Witness: Andrew J. Bazinet

2a – Connecticut Siting Council Late-Filed Exhibit:

Changes to exhibits that were identified by the CPV Towantic, LLC witnesses during the exhibit verification process at the January 15, 2015 public hearing.

Figure 5. (Page 1 of 2)

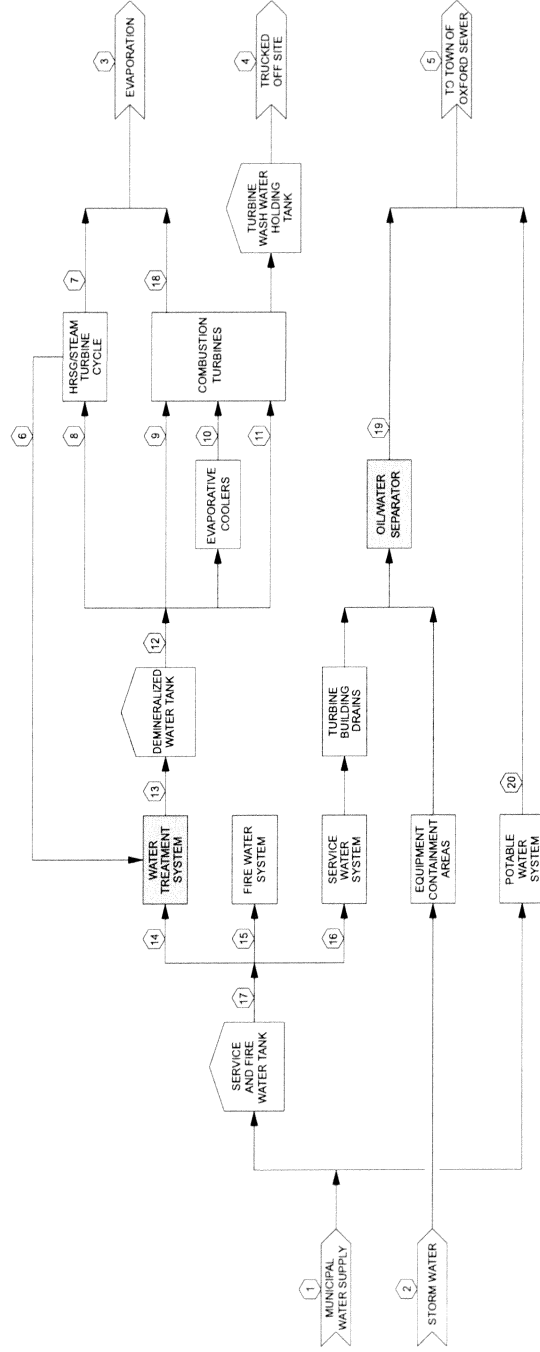
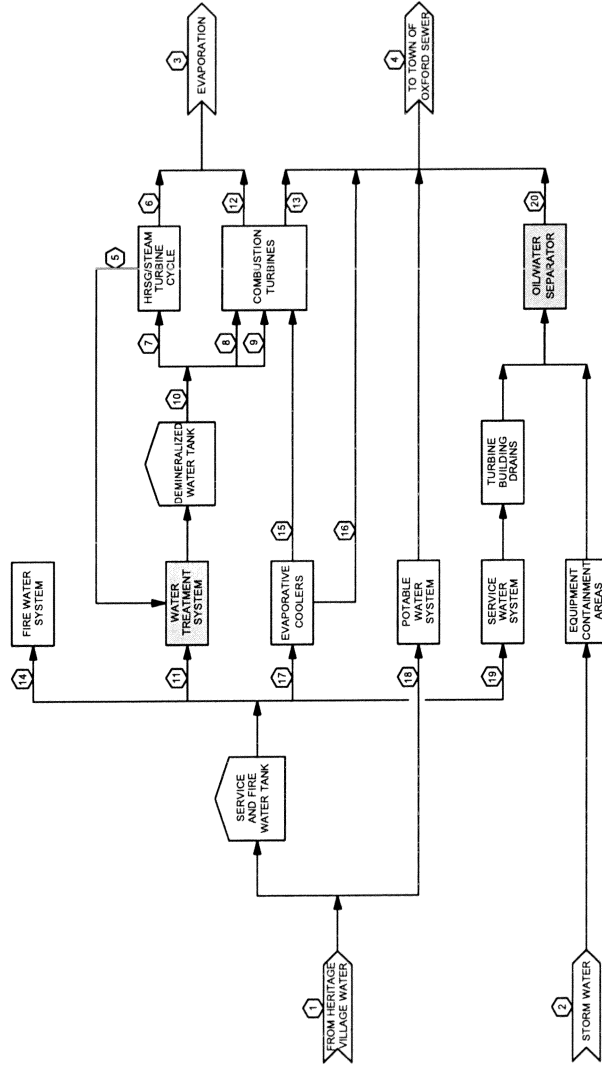
4. Sections 4.1.2.1, 4.1.2.2 and Figure 5 water balance on pages 26-29. Updated information on water use and discharge provided in Q-Naugatuck-1 and 3 and in the attachments to #3 above.

Wastewater quantities for the Project are shown on the water balance provided in Figure 5. Differences between the current configuration and the proposed Project are minimal but reduce overall wastewater flows:
